Access Compliance Report

Public Rights-of-Way

(Curb Ramps)

Intersection ID: 7668	Main Street: STONEFACE_RD	Cross Street: SULLINS_RD	Location: S
ADA ID: BEFADEC39957	Ramp Type: Perp	Initial Pass/Fail: Fail	Overall Compliance: No
		Severity Score: 8.75

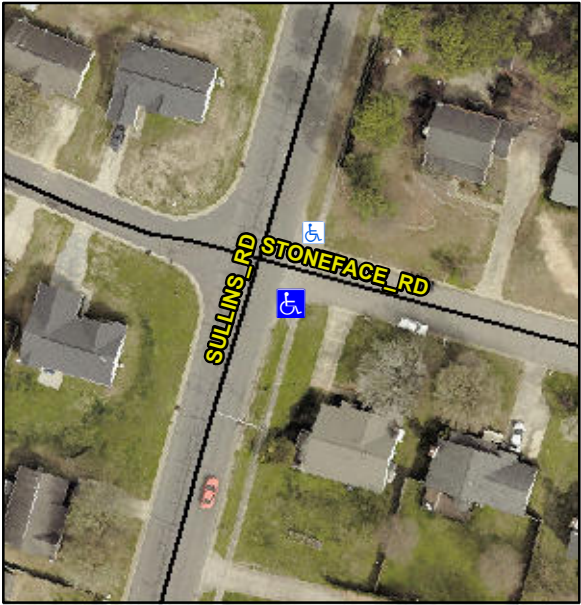
Codes/Mitigation Info/Possible Solution			Field Measurements/Component Compliance		
	Possible Solutions:		Compliance	Description	Data
	Remove & Replace Entire Ramp.		N/A	Ramp Length (in)	62.0
			No	Ramp Width (in)	41.0
			N/A	Flare Type LT	N/A
			N/A	Flare Slope LT (%)	N/A
			N/A	Flare Traversable LT?	N/A
			N/A	Landing Length (in)	N/A
			N/A	Landing Width (in)	N/A
			N/A	Landing Slope (%)	N/A
			N/A	Landing X Slope (%)	N/A
<p>Surveyor Notes:</p> <p>N/A</p> <p>PROW/ADA:</p> <p>Not Found, R304.5.1</p>			N/A	Flare Type RT	N/A
			N/A	Flare Slope RT (%)	N/A
			N/A	Flare Traversable RT?	N/A
			N/A	DWS Provided?	N/A
			N/A	DWS Contrast?	N/A
			N/A	DWS Length (in)	N/A
			N/A	DWS Full Width?	N/A
			N/A	DWS Offset (in)	N/A
			N/A	Shared Landing?	N/A
			N/A	Gutter Ponding?	N/A
			N/A	Gutter Lip Ht (in)	0.5
			N/A	Painted X Walk1?	No
				X Walk 1 Direction	To N
			N/A	X Walk 1 Width (in)	N/A
				X Walk 1 Slope (%)	4.5
				X Walk 1 X Slope (%)	0.1

N/A	Ramp inside XWalk1?	N/A
			N/A	Road Slope (%)	N/A
			N/A	Road X Slope (%)	N/A
			N/A	Any Obstructions?	N/A
Total Cost:		\$ 1850.00		Obstruction Type	
			N/A		N/A
			Yes	Surface Condition? (G/P)	Good
